HISTORIC AND DESIGN REVIEW COMMISSION

Agenda Item No: 14

HDRC CASE NO: 2016-171
ADDRESS: 1307 FULTON AVE
LEGAL DESCRIPTION: NCB 2754 BLK 60 LOT 23
ZONING: R4 H
CITY COUNCIL DIST.: 1
DISTRICT: Fulton Historic District
APPLICANT: Valerie Fuller
OWNER: Valerie Fuller/Fulco Properties LLC
TYPE OF WORK: Window replacement
REQUEST:

1307 Fulton Ave Window Proposal

On rear - not
replaced

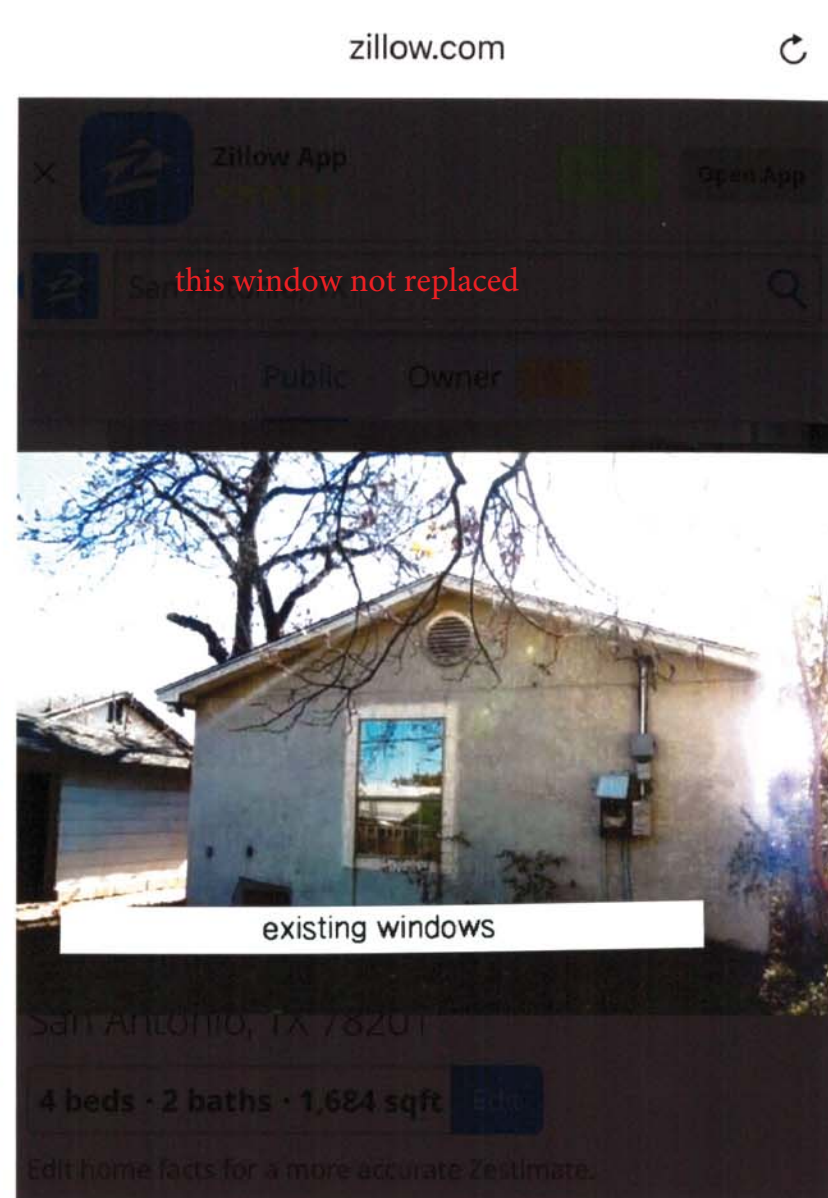
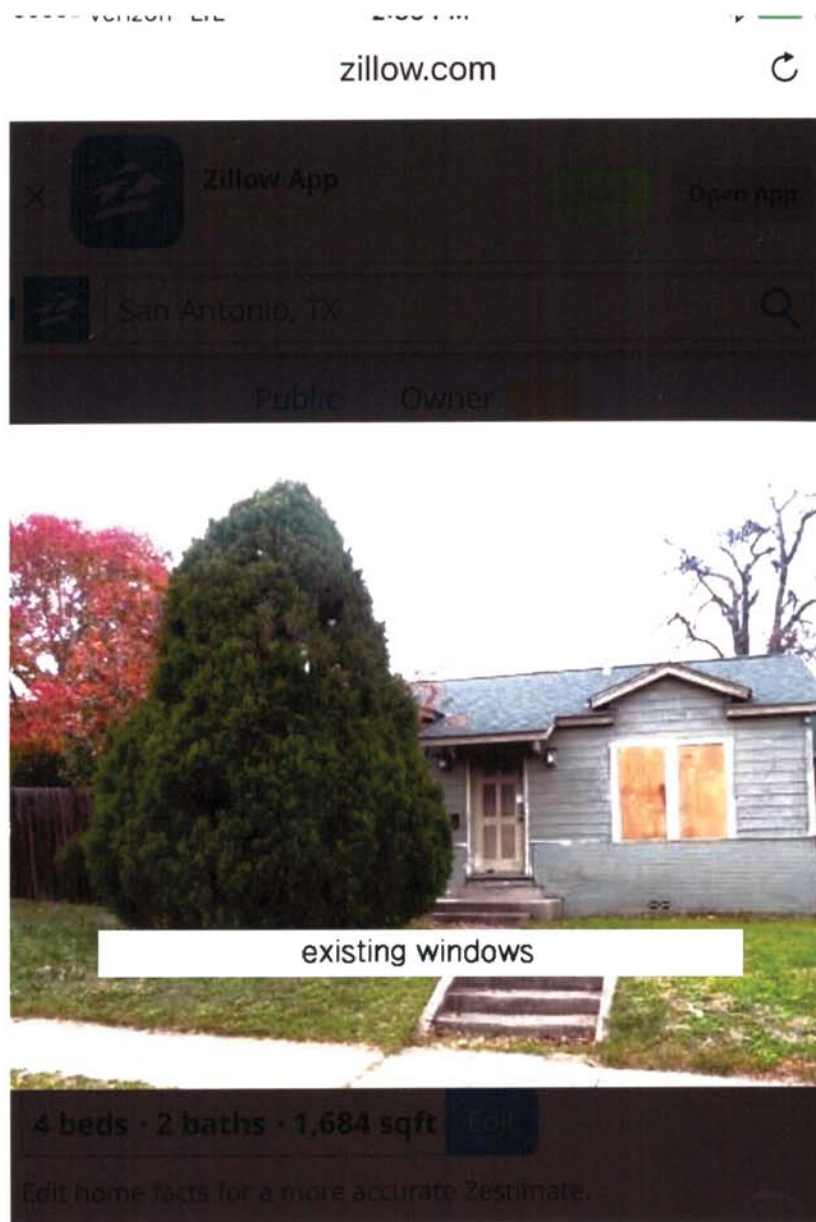
- c. The applicant is proposing to replace 12 wood windows with new 6 over 6 vinyl windows with divided lights to match those divided lights existing in the rear. According to the Guidelines for Maintenance and Alterations 6.A.iii., historic windows should be preserved unless 50% or more of a window's components must be reconstructed.
- d. Consistent with the Guidelines for Exterior Maintenance and Alterations, replacement windows must maintain original dimensions and profiles, feature clear glass, and should be recessed within the window frame. Windows with a nailing strip are not recommended. The corresponding pages from the adopted windows policy document have been added to the exhibits for this request. A window detail which illustrates conformance with the guidelines for windows has not been submitted.

Staff does not recommend approval based on findings a through d. Staff recommends that the wood windows be repaired or replaced with wood windows that maintain the original dimensions and profiles, feature clear glass, and recessed one to two inches within the window frame.
